## **Proposal for Supplement 4 to the 05 Series of Amendments to UN Regulation No. 95 (Lateral impact) \*,\*\***

### **Submitted by the expert from France**

### “Annex 5 – Appendix 2

#### FORCE-DEFLECTION CURVES FOR DYNAMIC TESTS

Figure 2a

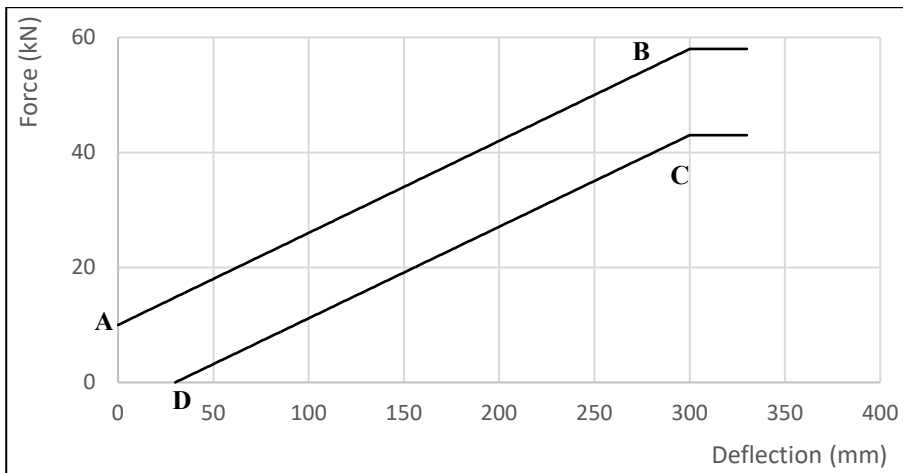
Deflection	Force
A	0 mm	10 kN
B	300 mm	58 kN
C	300 mm	43 kN
D	30 mm	0 kN

Figure 2b

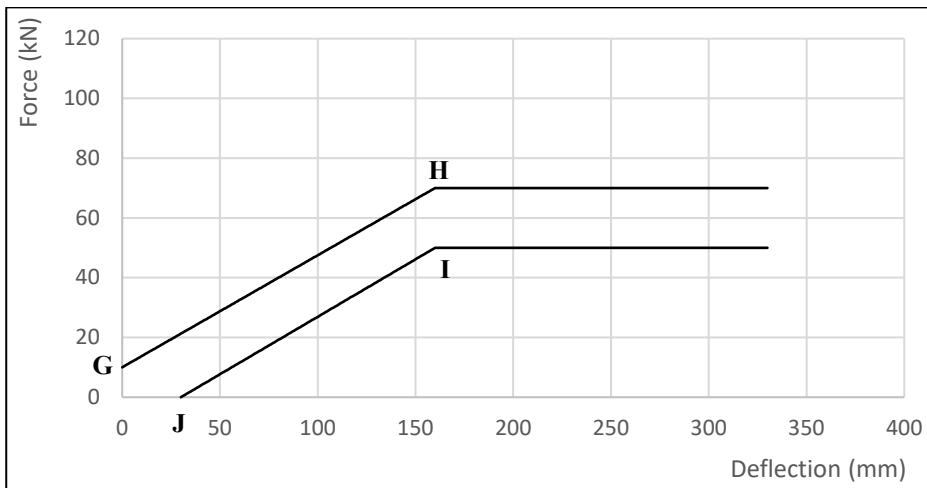
Deflection	Force
G	0 mm	10 kN
H	160 mm	70 kN
I	160 mm	50 kN
J	30 mm	0 kN

Figure 2c

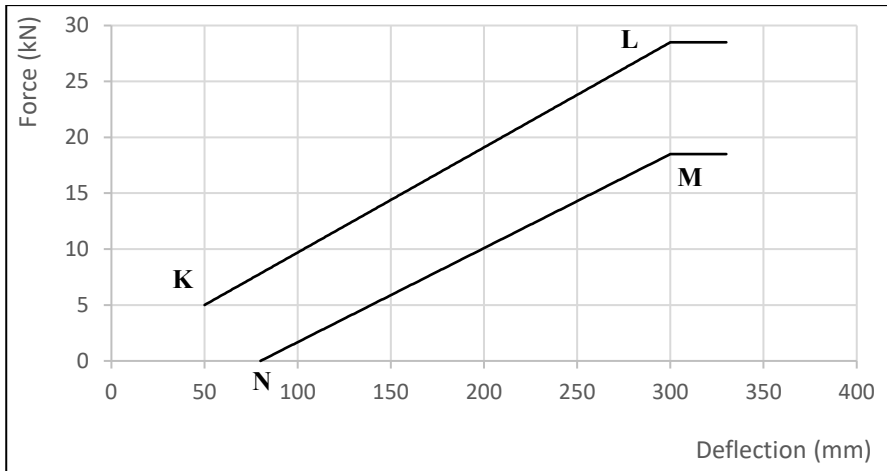
Deflection	Force
K	50 mm	5,0 kN
L	300 mm	28,5 kN
M	300 mm	18,5 kN
N	80 mm	0 kN

Figure 2d

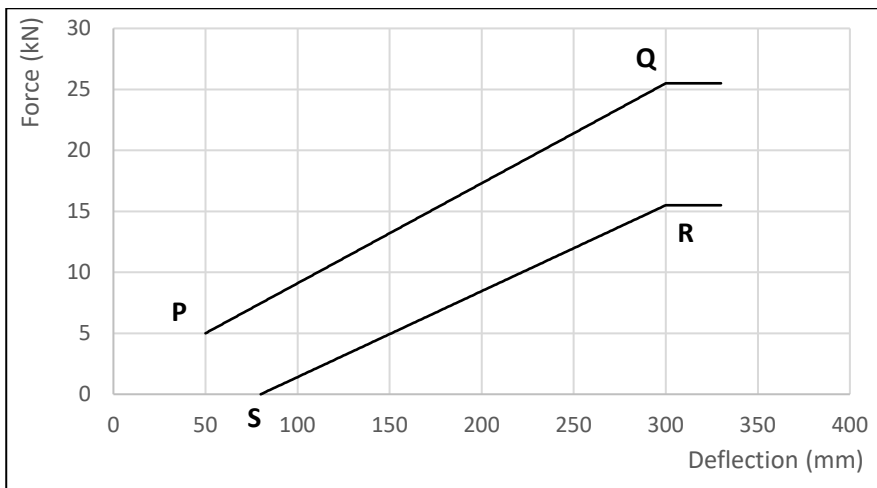
Deflection	Force
P	50 mm	5,0 kN
Q	300 mm	25,5 kN
R	300 mm	15,5 kN
S	80 mm	0 kN

Figure 2e

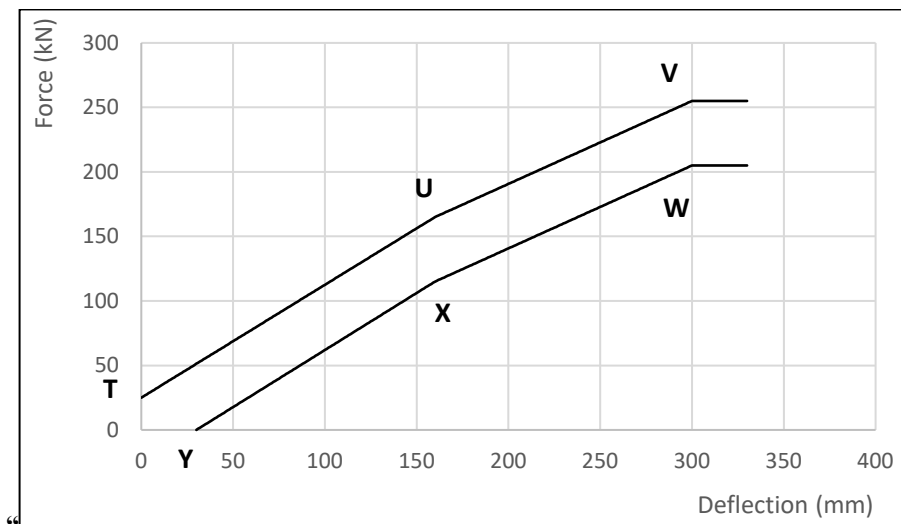
Deflection	Force
T	0 mm	25 kN
U	160 mm	165 kN
V	300 mm	255 kN
W	300 mm	205 kN
X	160 mm	115 kN
Y	30 mm	0 kN

Figure 2a  
Blocks 1 & 3

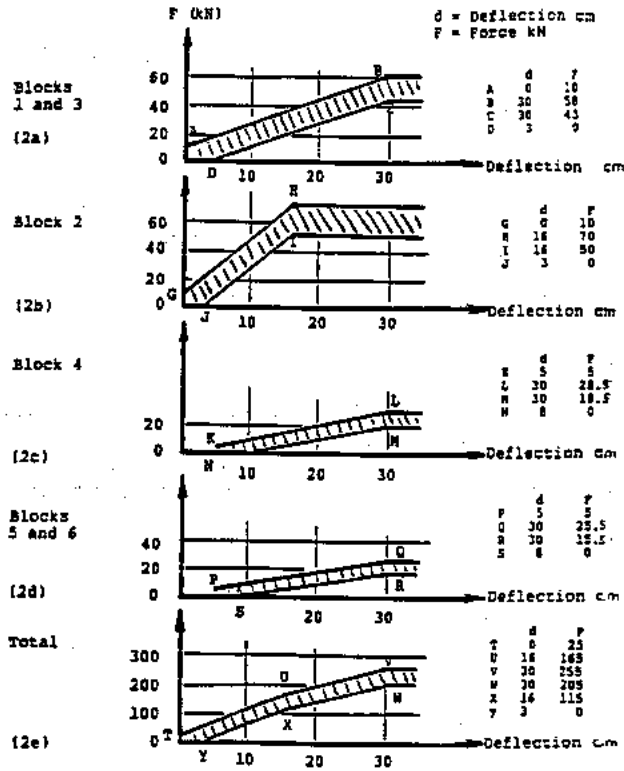
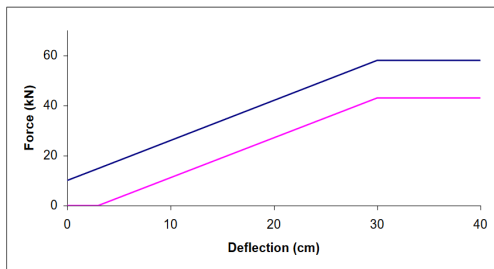
- This proposal aims at clarifying the force-deflection curves of Annex 5 – Appendix 2. The force-deflection corridors characterising the rigidity of the impactor were described in the original series of the UN Regulation No. 95 with a legend precisising the value of the characteristics points of the curves (A to Y).

In the serie 2 of amendments, the figures were updated (without changing the corridors) and the legend were removed.

This proposal aims at reintroducing the letters and the value in the legend for more clarity. The units of the deflection were also modified from cm to mm to be aligned with the units used in the rest of the text.
